RADIAN
CORPORATION
May 30, 1989

Re: Revised Work Plan
Stage 2 Remedial Investigation
Emerson Power Transmission, Ithaca, New York

REVISED WORK PLAN FOR
STAGE 2 REMEDIAL INVESTIGATION
EMERSON POWER TRANSMISSION
ITHACA, NEW YORK

Figure 2. Locations of Existing and Proposed Monitoring Wells at Emerson Power Transmission Ithaca, New York

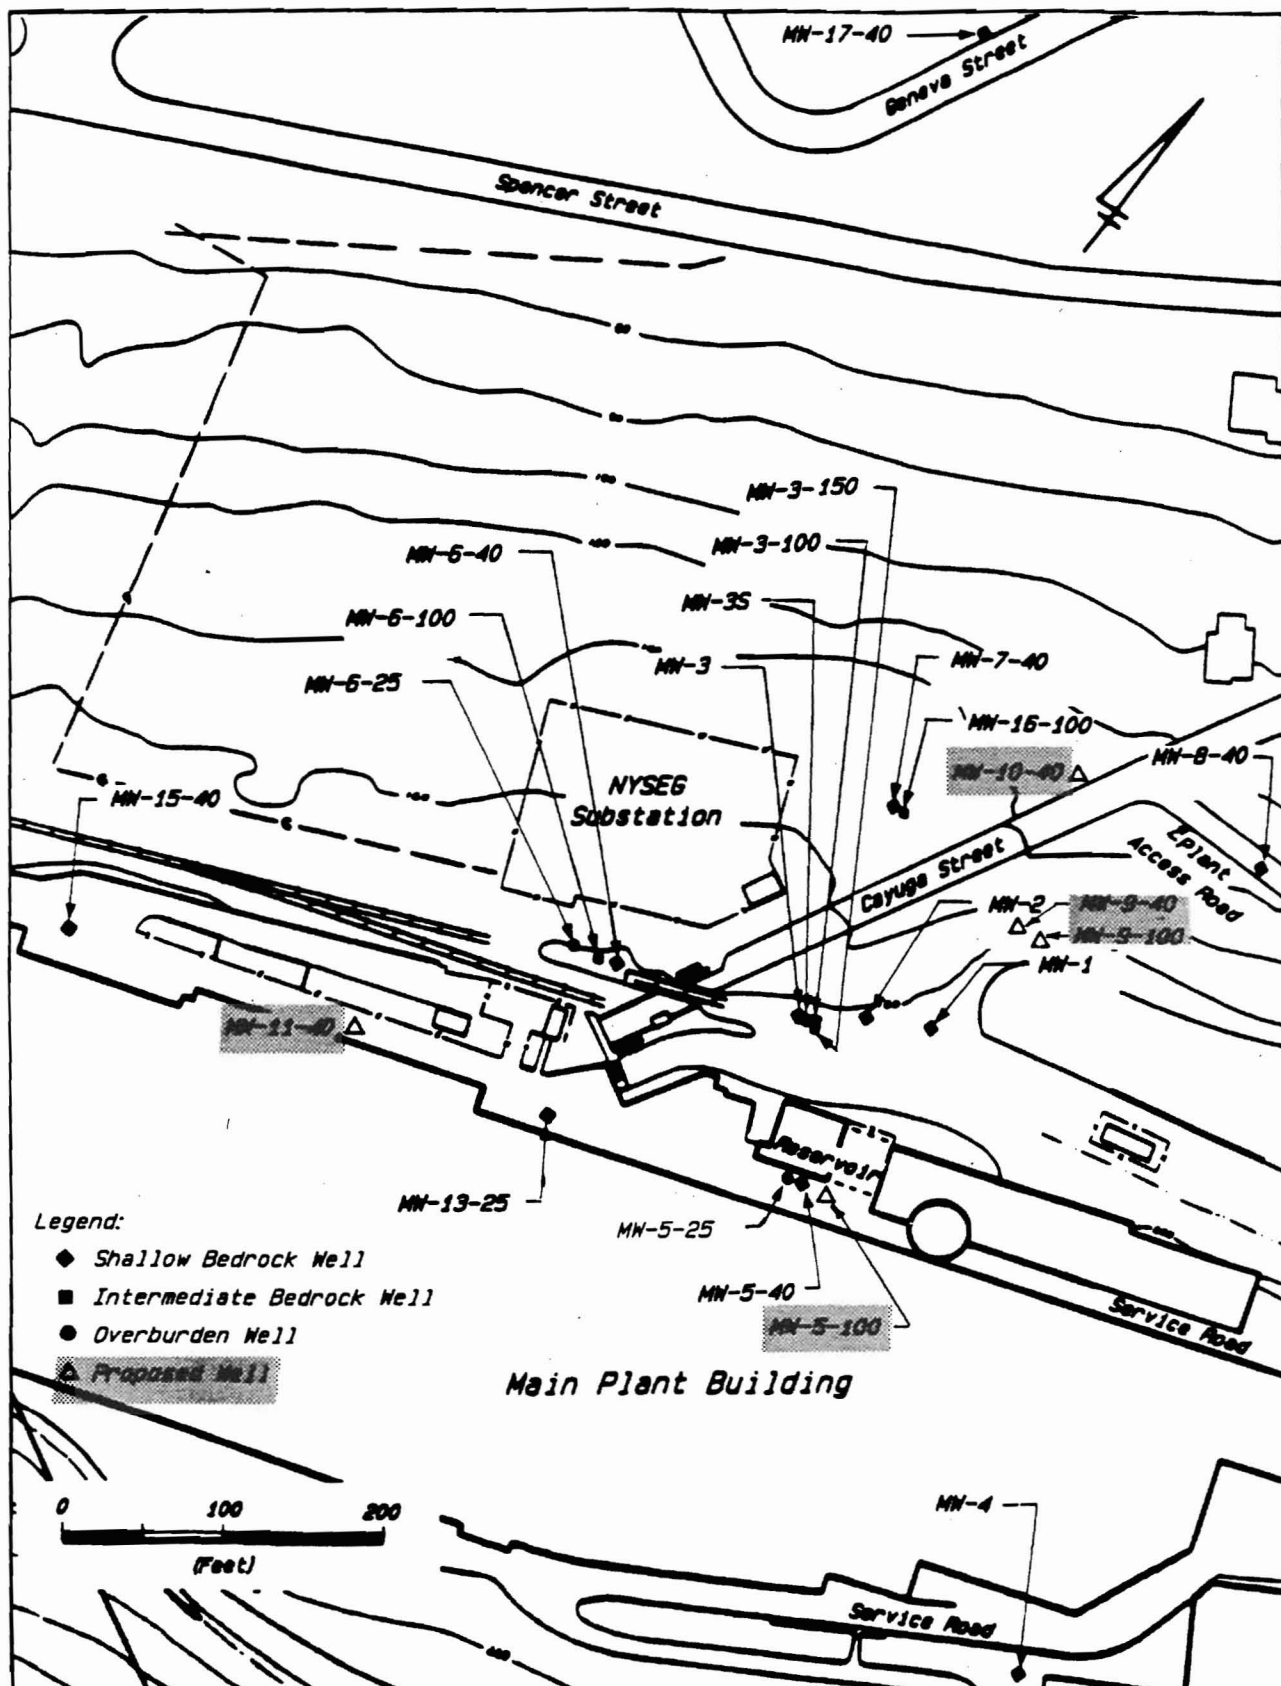
2. In a conversation with Ms. McCormick, it was agreed upon that five Stage 2 wells will be installed, but that some of the locations would change. Well MW-10-40 will be moved from the proposed location to Spencer Street, in a east-northeasterly direction from wells MW-1, MW-2, and MW-3 and along the orientation of the fracture traces.
3. The MW-9 well cluster will be moved from the proposed location to a position at the intersection of the plant access road and Cayuga Street. The wells will be located on the southeastern corner of this intersection, which will place them in the northeasterly downgradient direction from the MW-3 cluster.
4. Seep F was added to the seep sampling program. Its omission was an oversight.

Installation of five additional wells is proposed for the Stage 2 investigation. The proposed locations of the Stage 2 wells are shown on Figure 2. All locations indicated are proposed and may need to be adjusted in the field depending on the conditions encountered. If changes to the planned locations are necessary, concurrence will be obtained from the designated NYSDEC representative prior to use of an alternate location.

Proposed well MW-10-40 will be located along Spencer Street, east-northeast of the MW-3 and MW-2 wells and along the orientation of the fractures in the bedrock. To provide additional information on the furthest lateral extent of TCE and associated compounds in this area, well MW-10-40 will be located downgradient of the reservoir and the property line, and installed to a depth of approximately 40 feet.
